**PHAP13-00030**

**Date:** November 4, 2013  
**Application Type:** Certificate of Appropriateness  
**Property Owner:** Don Luciano  
**Representative:** Guillermo Barajas  
**Legal Description:** 36 Manhattan Heights 20 To 24, City of El Paso, El Paso County, Texas  
**Historic District:** Manhattan Heights  
**Location:** 1315 Elm Street  
**Representative District:** #2  
**Existing Zoning:** R-3/H (Residential/Historic)  
**Year Built:** 1913  
**Historic Status:** Contributing  
**Request:** Certificate of Appropriateness for the rehabilitation of the subject property, construction of a garage structure, construction of a concrete wall and metal picket fence, installation of walkways, cementing portions of the parkway, construction of concrete pads, and landscaping.

**ITEM #1**

# PROPOSED SITE PLAN

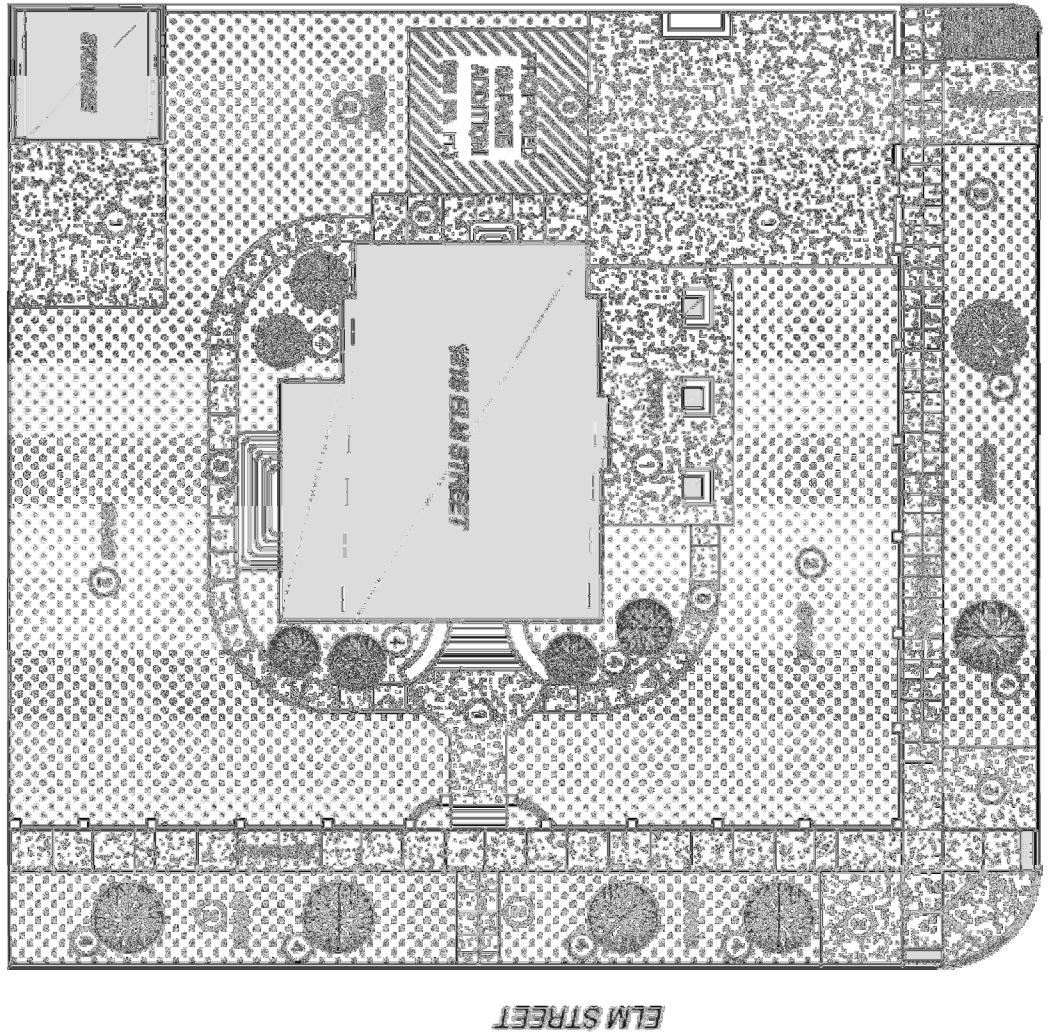
*The modifications are that the size of the concrete pad/driveway leading to the proposed garage on the north portion of the property be reduced to a maximum of twelve feet in width; that the basement windows be replaced with fixed windows and not masonry; that the southeast corner on the second story be infilled with windows and walls with wood shingles to match the proposed infill on the main and secondary facades; that the new brick and mortar match the original brick and mortar in color, texture, size, dimensions, and pattern; that the brick infill on the first floor be topped with a coping as seen in the historic photographs; that the concrete slab in front of the rear structure be replaced with grass; and that the concrete wall constructed on the south property line be covered with a rock veneer to match the existing rock wall at the rear of the property on the west property line.*
